Access Compliance Report Public Rights-of-Way (Curb Ramps)

Main Street: GLENAIRE_DR		Cross Street: ARROYO_AVE		Location:	N
ADA ID: RPRK211013115457	Ramp Type: Type 4 - Parallel	Initial Pass/Fail: Fail	Overall Compliance: No	Severity Score:	45
Codes/Mitigation Info/Possible Solution			Field Measurements/Component Compliance

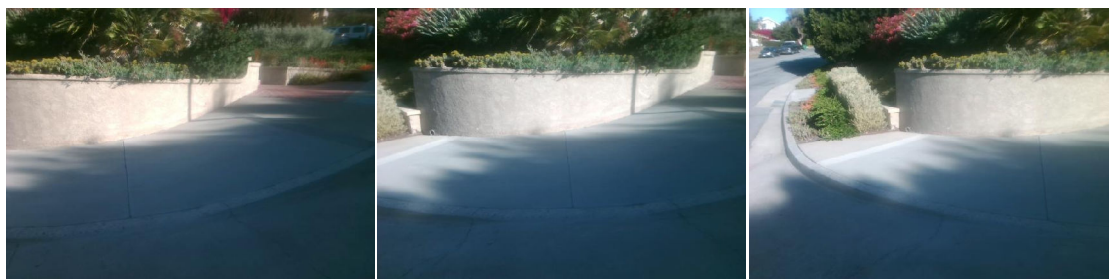
R204.3, R304.5.3, R304.3.2, R302.7.2, STD 1115

Remove & Replace Curb Ramp With Two New Directional Ramps or Equivalent. Grind Gutter Lip.
